Rev 1.0

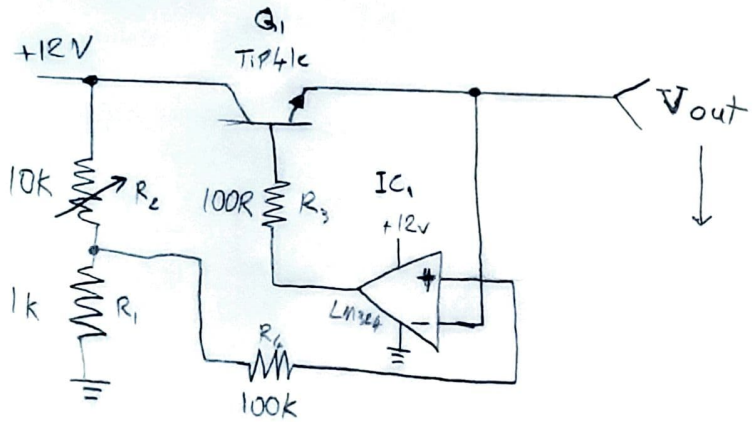
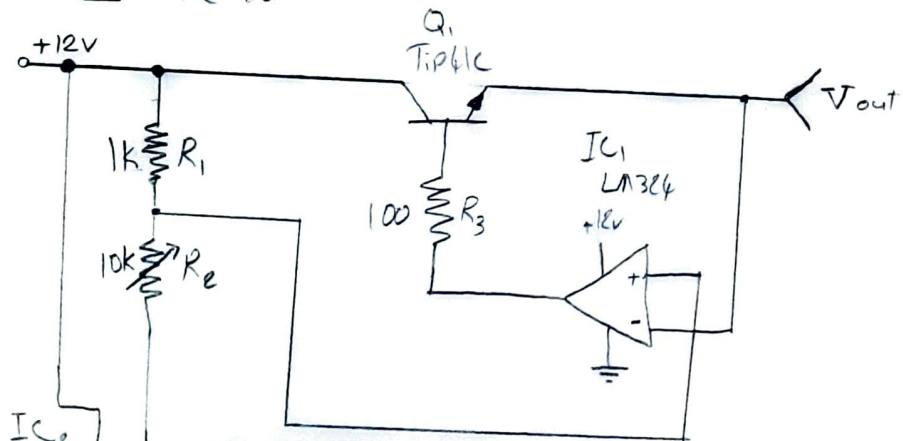
* Change R_1 with R_2 .

* Add reference voltage with adequate amplification.

* Voltage divider should use a reference voltage.
